July 2012

Proposed Rights of Way Mitigation

**Plan 4**

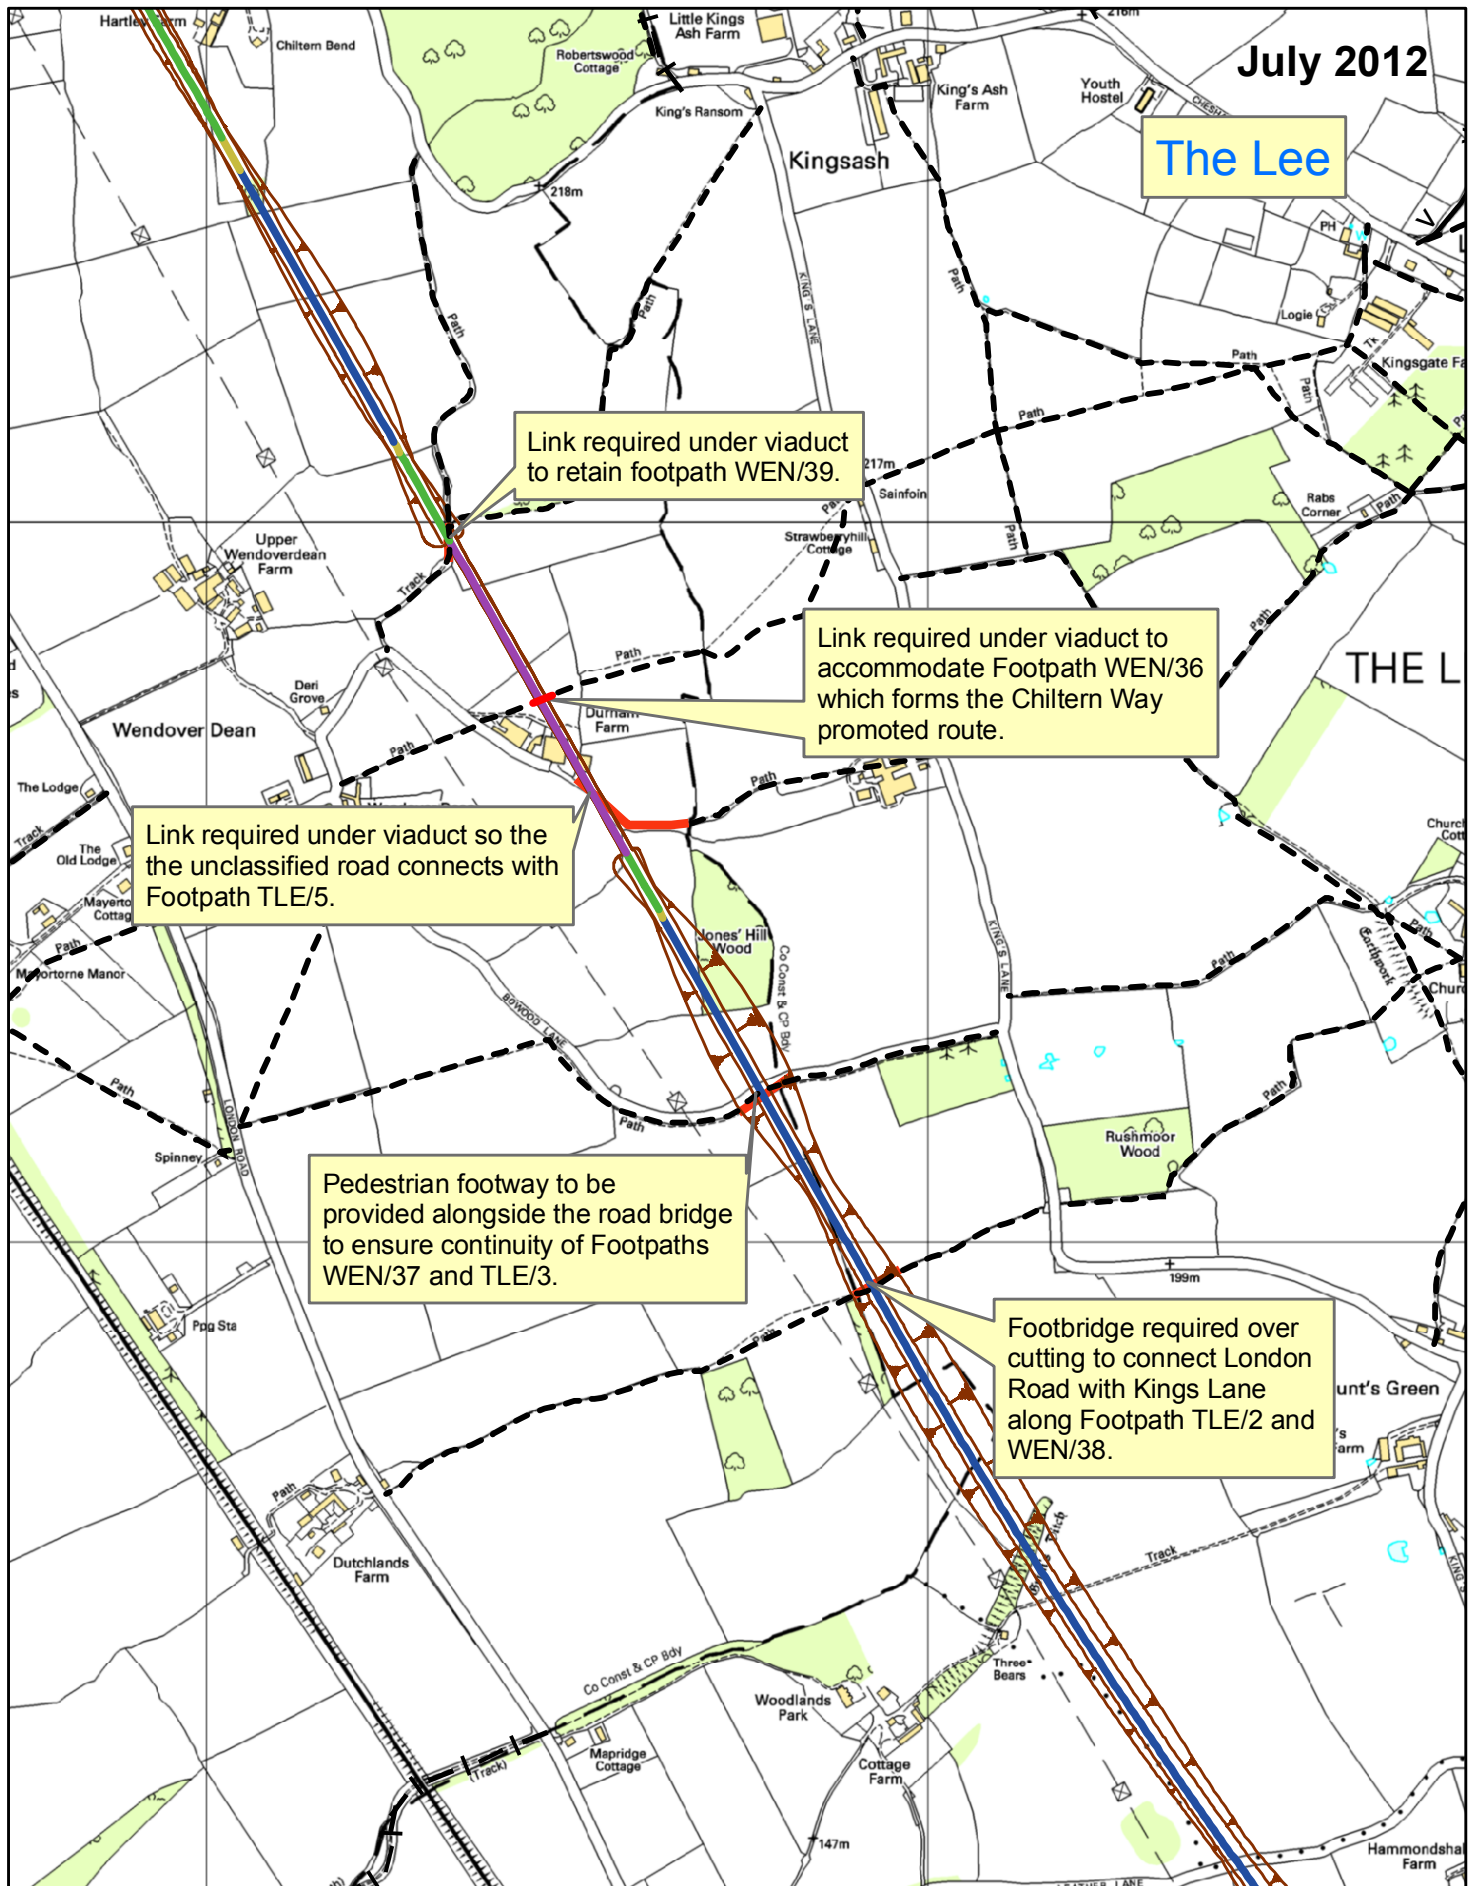
Link required under viaduct to retain footpath WEN/39.

Link required under viaduct to accommodate Footpath WEN/36 which forms the Chiltern Way promoted route.

Link required under viaduct so the unclassified road connects with Footpath TLE/5.

Pedestrian footway to be provided alongside the road bridge to ensure continuity of Footpaths WEN/37 and TLE/3.

Footbridge required over cutting to connect London Road with Kings Lane along Footpath TLE/2 and WEN/38.
